**PERSIMMON HOMES THAMES VALLEY
LAND NORTH OF TODDINGTON LANE,
LITTLEHAMPTON**

**DRAINAGE STRATEGY, WEST OF
WETLANDS
(DISCHARGE OF CONDITION 10)**

JANUARY 2019

Project Code:	A/PHDRAIN.10
Prepared by:	SF
Approved by:	AB
Issue Date:	24th January 2019
Status:	1st Issue

Image below: Shows the locations of the permeable sub-base within the Windes model..

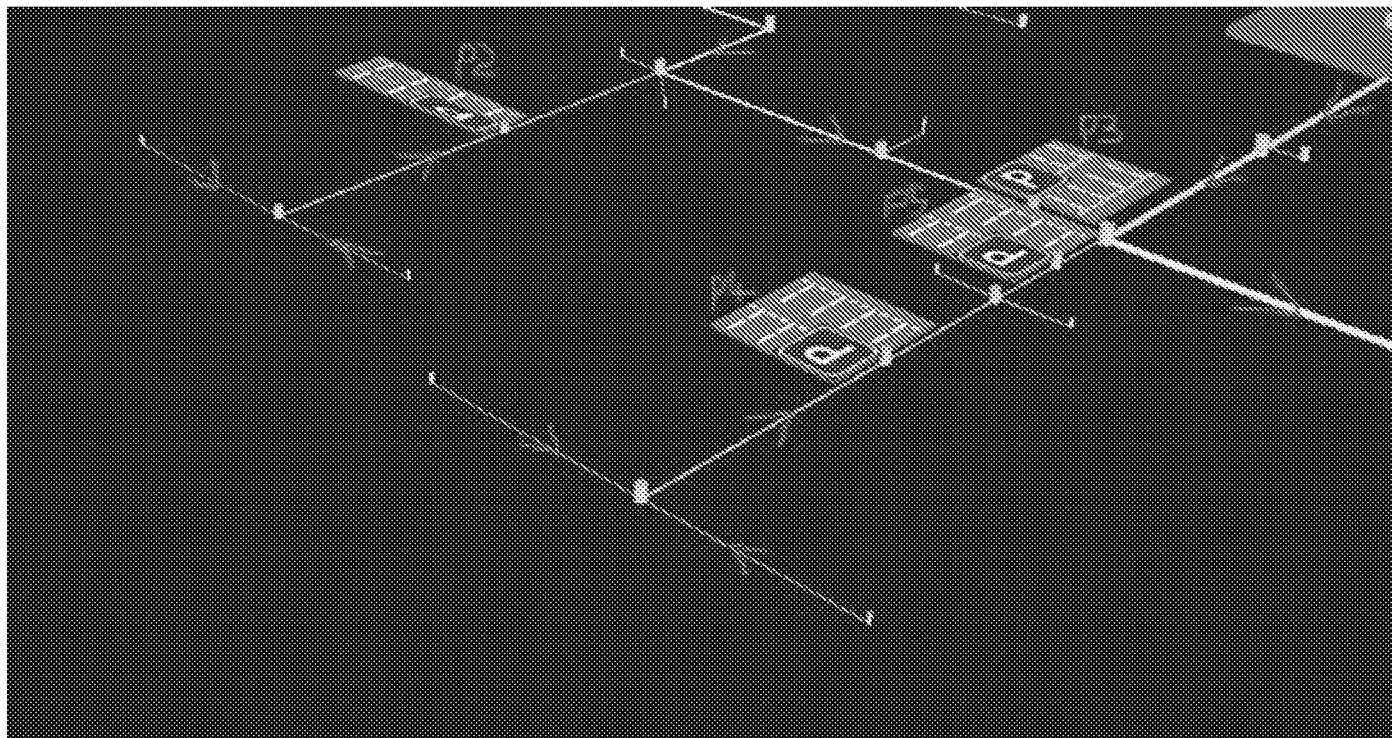
- The location of the permeable sub-base is also on the road build-up and finishes drawing. (See point 7 above) See point 3
9. Please can you model the permeable sub base roads to demonstrate if the flooded volume can be stored. Check dams etc. may need to be provided.

Whilst reading the response below please note we have updated our Windes model so it now includes the permeable sub-base. See image below where we've added new nodes and modelled is as a "porous car park" (function within the programme) where the storage within 30% voids of the granular sub-base is recognised. We have distributed it as evenly as possible across the areas where the granular sub-base is located. The addition improves the results significantly and the total flooding volume for the fully surcharged critical 1in100yr+CC storm is now only 35m3 (spread across 4 different locations) that can safely be contained within the site.

- We have added the permeable sub-base to the micro drainage model so the storage within the open graded sub-base is now included. There is no need to include check dams because the volume of the sub-base is utilised / required for the long duration. The site does slope, is subbase of all permeable subbases to be laid flat? Clarification and details of this under point 3 will be required. I will complete a full review of the calculations once point 3 is provided.
